Addendum 1 for Tenant Design Manuals

- 1) 2.4.3 Optional Signage in the Tenant Design Manual for Terminal A, B, C & E dated October 2006 AND
- 2) 3.2.3 in the Tenant Design Manual Terminal D, dated May 14, 2004

Figure 2.4 – Plan/Optional Signage Location

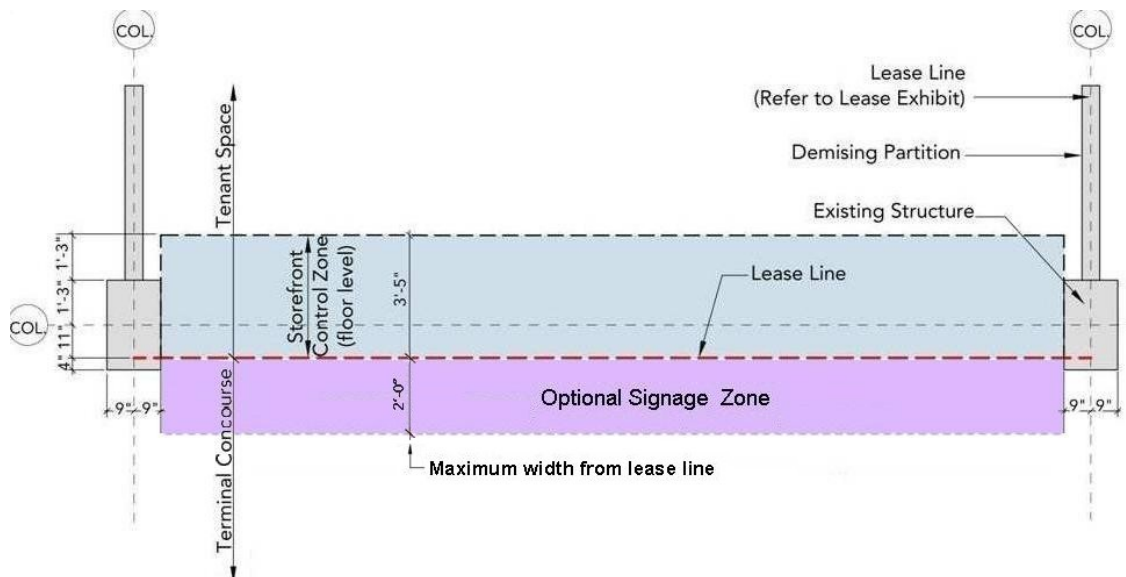
Replace the above sections with the update below.

Special graphics and temporary displays may be placed within the SCZ or the storefront enclosure, but only with approval by the Airport. The Tenants must comply with the following criteria:

1. Limit each concession location to **one** supplemental sign.
2. Maximum overall height may not exceed 5 ft and maximum width may not exceed 2 ft.
3. All signs must be double sided.
4. The sign must be of a stable design otherwise it will be subject to removal.
5. Must be produced of durable materials with a professional quality appearance.
5. The sign must physically touch the lease space.
6. Any variance to the above would be via written request only and be subject to approval by the Concessions Department.
